Architect's Field Report

18056-Warren Central Junior High School / Report Number 021

Date / Time 30 March 2021 / 1:30 PM

Figure 3 – Asphalt Flashing will require repair/replacement

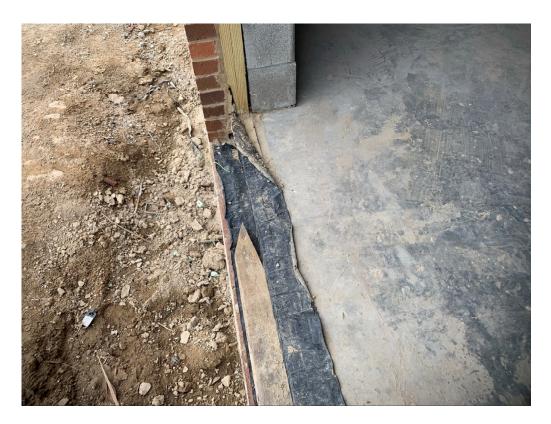
Membrane Flashing at windows will need to be replaced were damaged before window installation.

Figure 8 – Mortar Spills on New Concrete

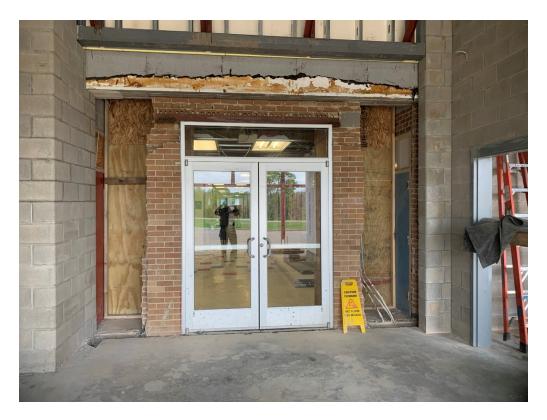
Also, in this area, mortar has been spilled at our new concrete entry platform that needs to be removed without damaging our new concrete brushed finish.

Figure 14 – Difference Between New Slab & Sidewalk appears to require at least 36' of ramp to maintain 1:12 slope min but preferably should be 1:20 (60')

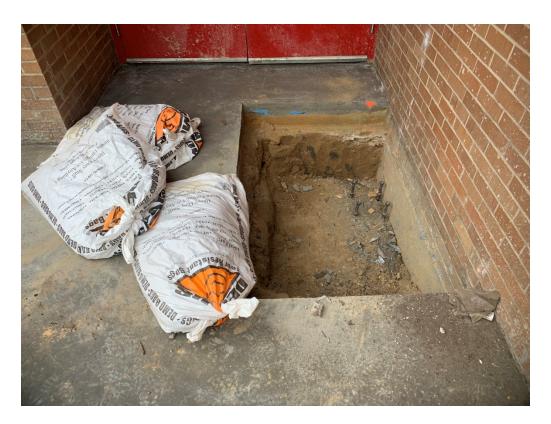
The new concrete foundation appears to be around 3-4" taller than the nearest sidewalk. Be sure to maintain a slope no greater than the 1:12 required in the contract documents.
